Conceptual Review Agenda

Schedule for 12/21/15 to 12/21/15

811 Elizabeth St Replat and Single-Family Home

Re: 811 Elizabeth St - Replat and Single-Family Home

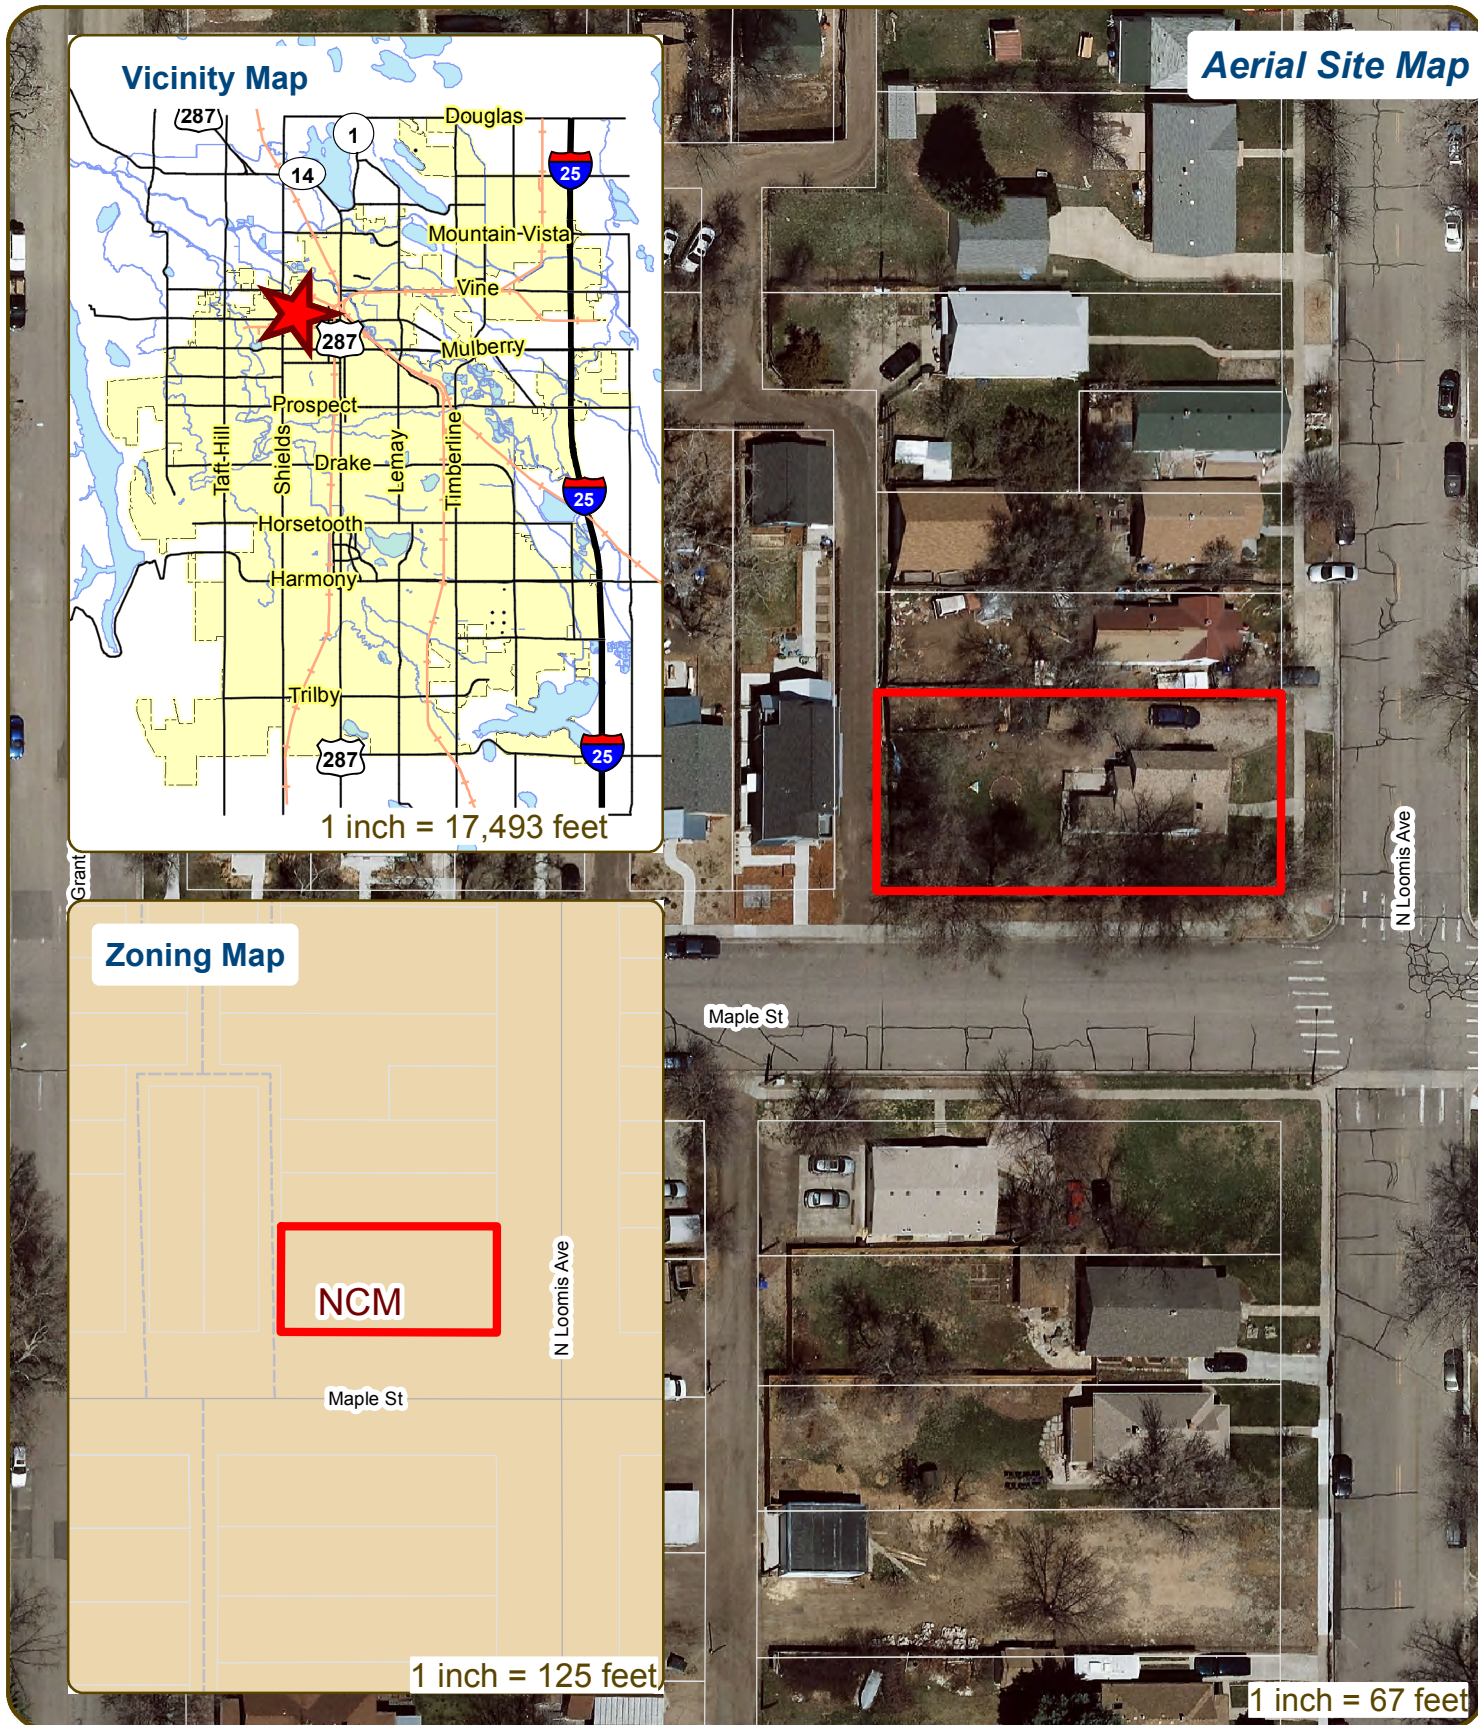
7. Please reference LUC Section 4.20(D)(3) for specific guidance related to building design, colors, and materials for the restrooms.
8. Plants and landscape materials that are native to the river corridor should form the basis of the landscape design to enhance the natural qualities of the river corridor.

9. Note the minimum species diversity requirements for new trees to be planted. See LUC Section 3.2.1(D)(3) for specific requirements.
10. How many parking spaces will be included in the parking lot? Note that 6 percent of the interior space of the parking lot (if less than 100 spaces) should be landscaped area. Landscape islands are required every 15 parking spaces (at a minimum).

11. Connecting walkways should be provide along all sides of the parking lot. There do not appear to be any walkways on the east side of the parking lot.

Project: SITE PLAN	Sheet: SITE
Date: December 8, 2015	
Scale: On Drawing

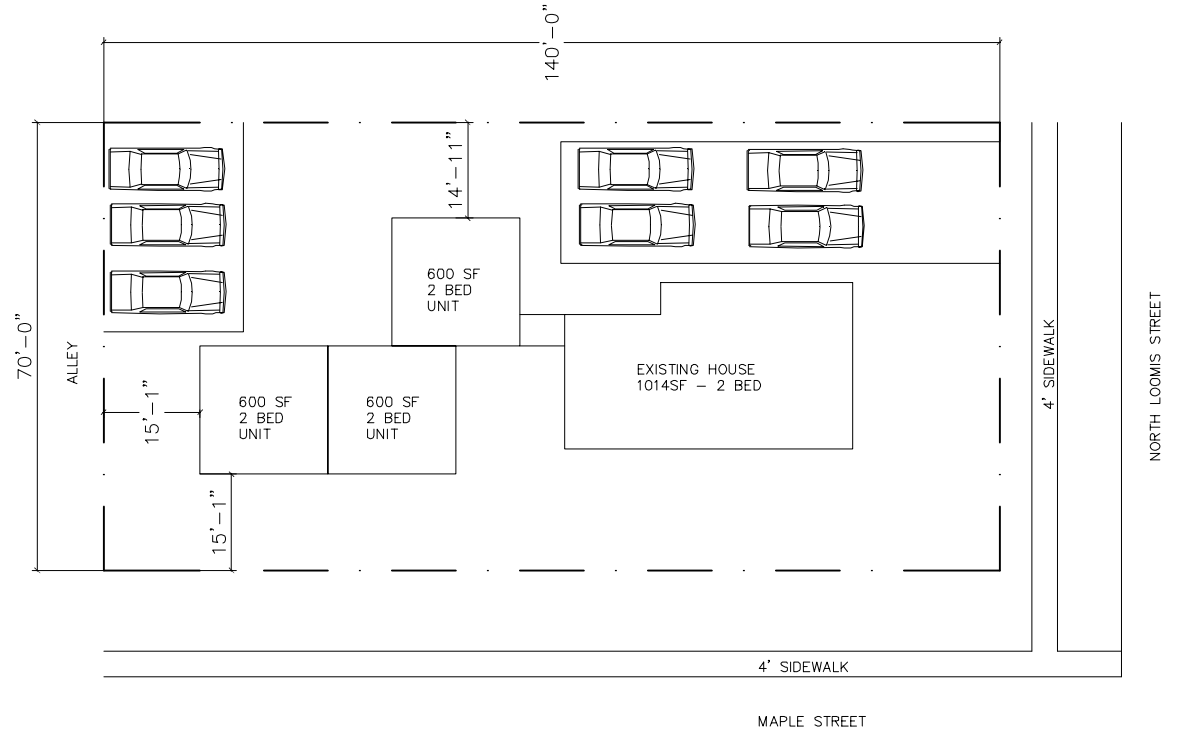
1. LUC 3.2.2(C)(4)(b) 1 Bicycle parking space is required per bedroom. 60% of these need to be enclosed, 40% can be fixed racks.
2. LUC 3.2.5 All development shall provide adequately sized conveniently located, accessible trash and recycling enclosures.
3. LUC 3.2.2(J) A 5 foot landscaped setback area is required along the side lot lines.
4. Are you proposing one structure or two with a breezeway?
5. The rear yard setback is 5 feet from an alley.

2. Section 3.2.2(K)(1)(a) requires that multi-family dwellings with 2 bedrooms provide 1.75 parking spaces per unit ($4*1.75=7$ parking spaces). The two easternmost parking spaces preclude the use of those behind them and therefore cannot be counted toward the requirement.
